Form: **Addendum #1**  
Project Title: **IFB 26-17 Building 30-39 Boiler Plant Upgrades**  
Issued Date: **February 27, 2026**

**BUILDING 30/39 BOILER PLANT UPGRADES FOR STOCKTON UNIVERSITY**  
 101 VERA KING FERRIS DRIVE, GALLOWAY, NJ 08205

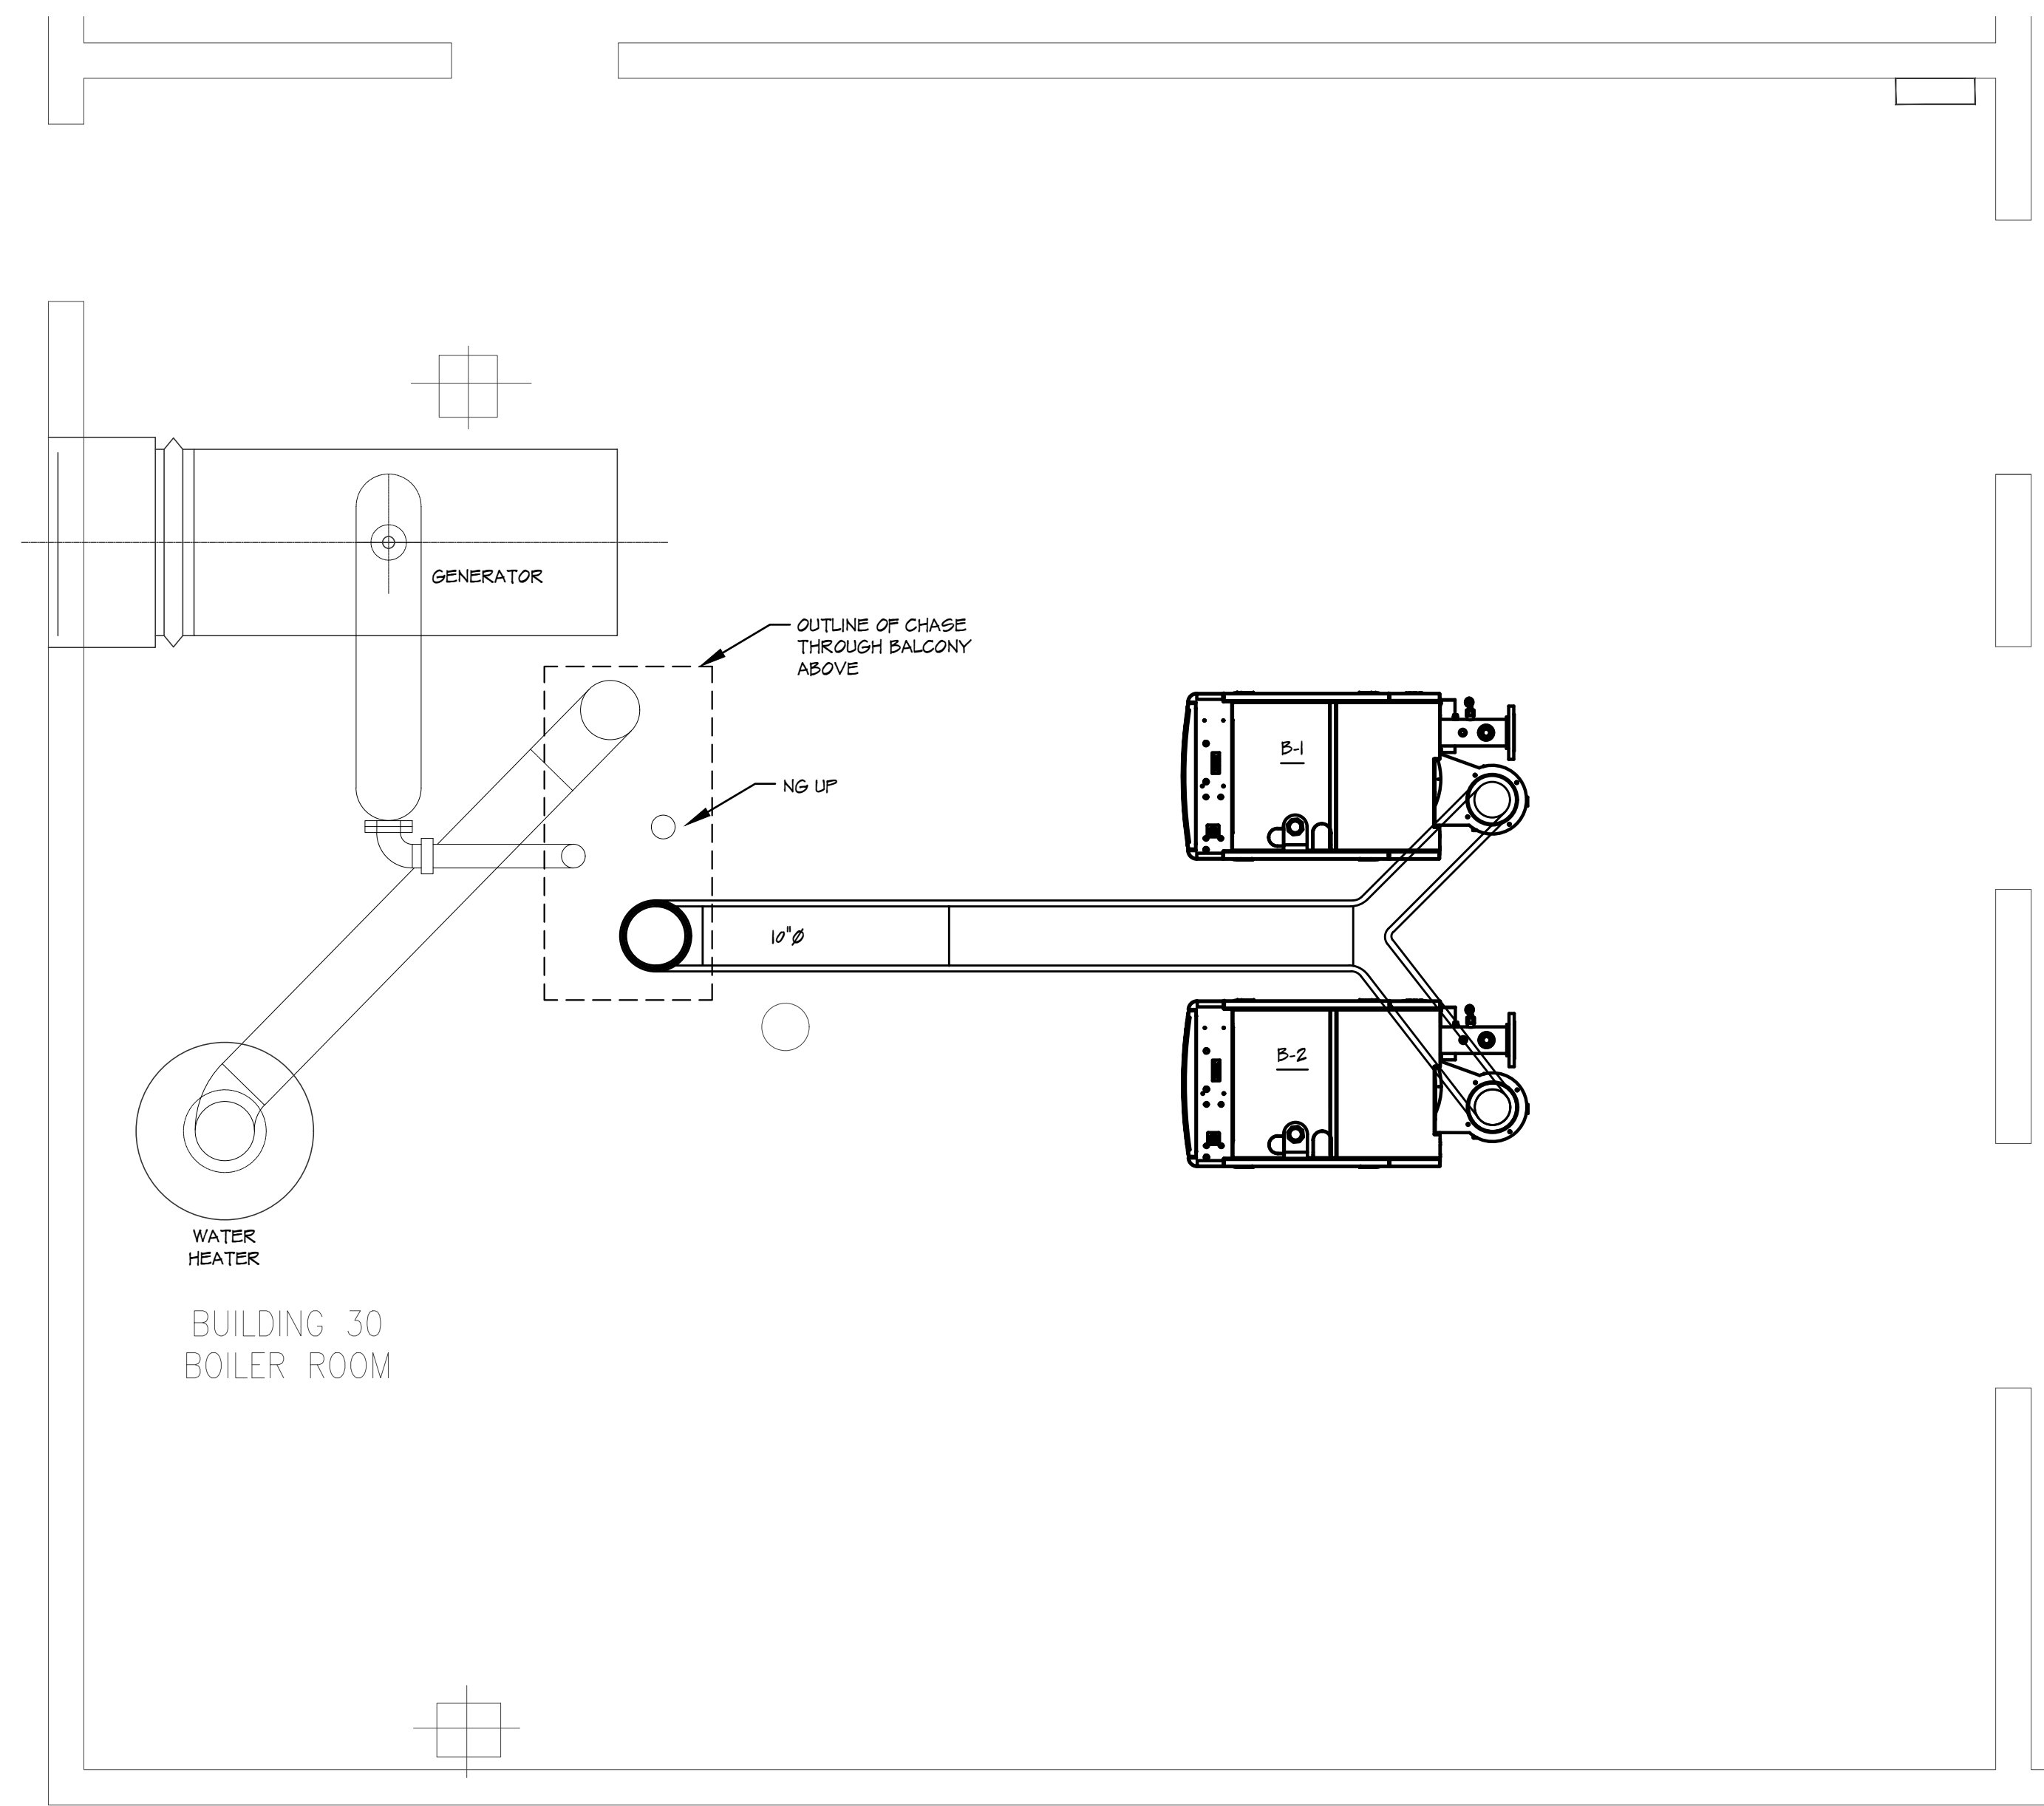
Are there any known asbestos and lead paint in these two buildings?

**The silver insulation on the existing boiler flue piping at building 30 came back positive for asbestos containing materials (ACM), see picture below for context, and attached results from AMSL Analytical, Inc. for reference. At this time the University plans to abate the referenced ACM under a separate contract and looking to have this work completed before the start of construction.**

Sheet Title  
 BUILDING 30 MECHANICAL SK-1

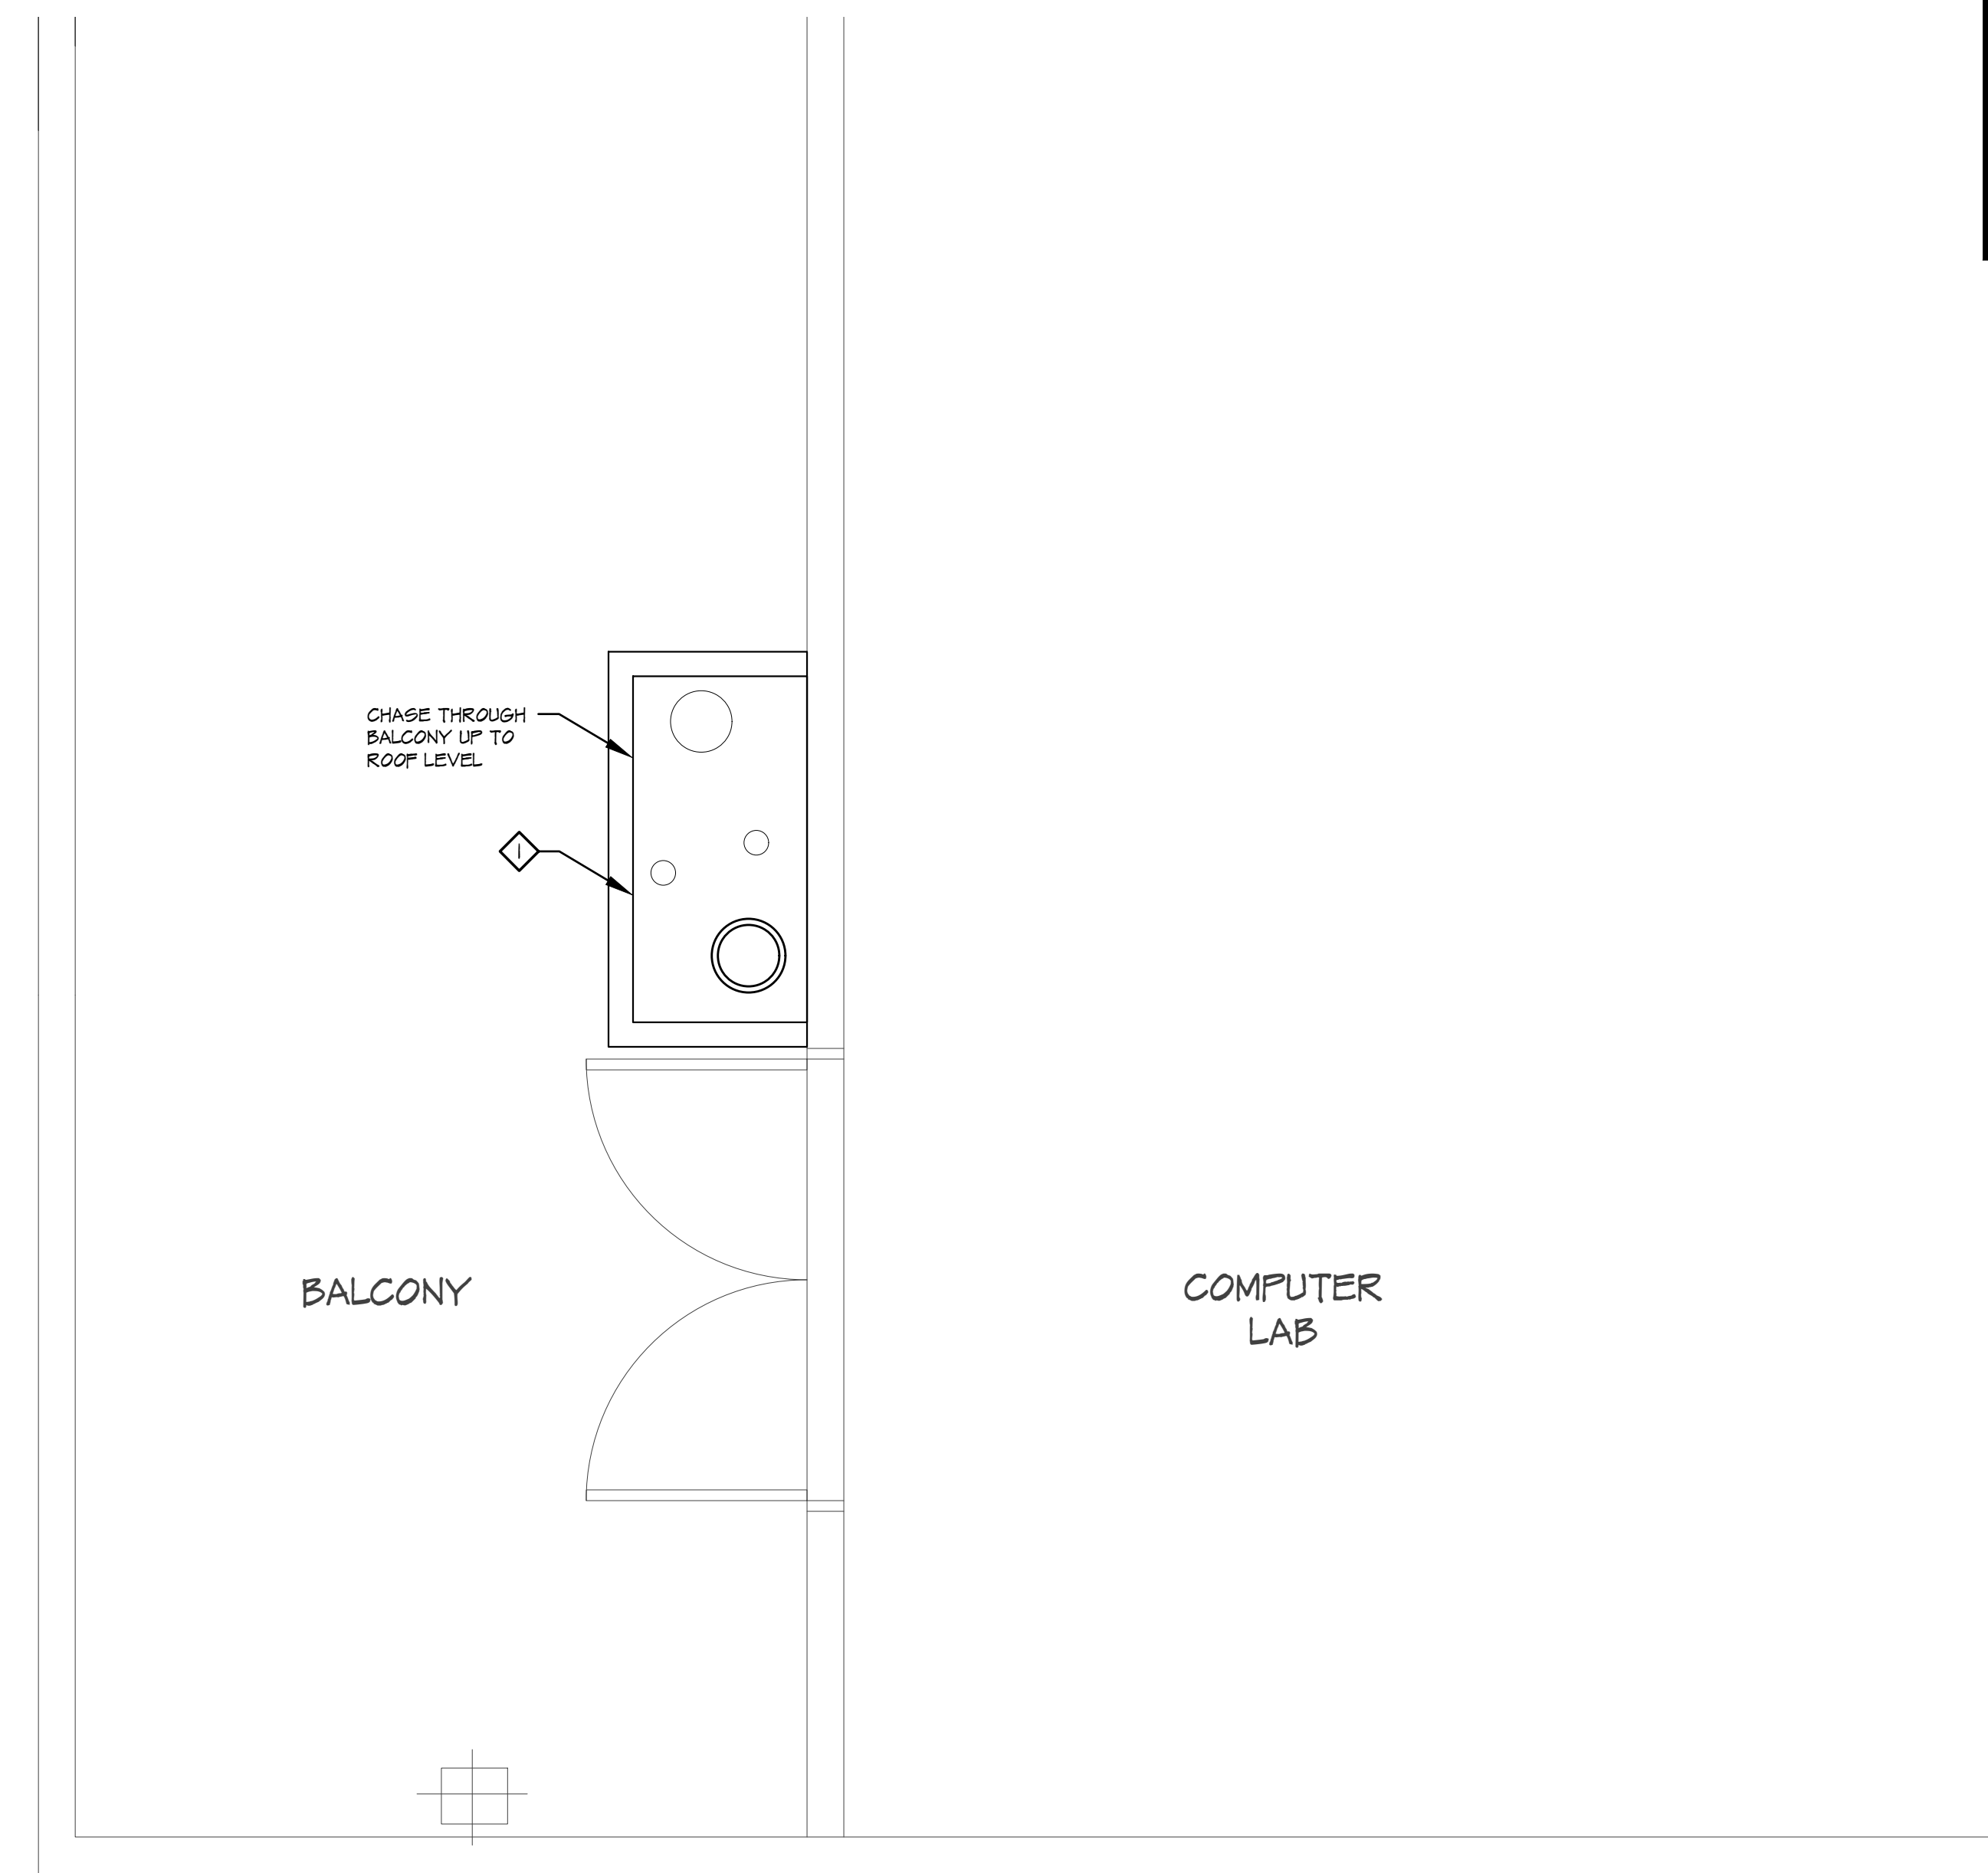
Please provide a detail of the shaft for the flue demolition through the second floor of Building 30.

The boiler flue is routed inside a chase through a second floor Balcony to the roof level. See picture below and attached sketch SK-1.

- 1 CHASE CONSTRUCTED OF INSULATED METAL PANELS INSTALLED ON METAL FRAMING. CONTRACTOR MAY CUT ACCESS OPENING(S) IN CHASE TO PERMIT ACCESS TO INSTALL NEW BOILER FLUE SYSTEM. INSTALL HINGED METAL ACCESS PANEL AND PAINT TO MATCH COLOR OF EXISTING ADJACENT PANELS AT COMPLETION OF FLUE INSTALLATION TO SEAL OPENING(S).
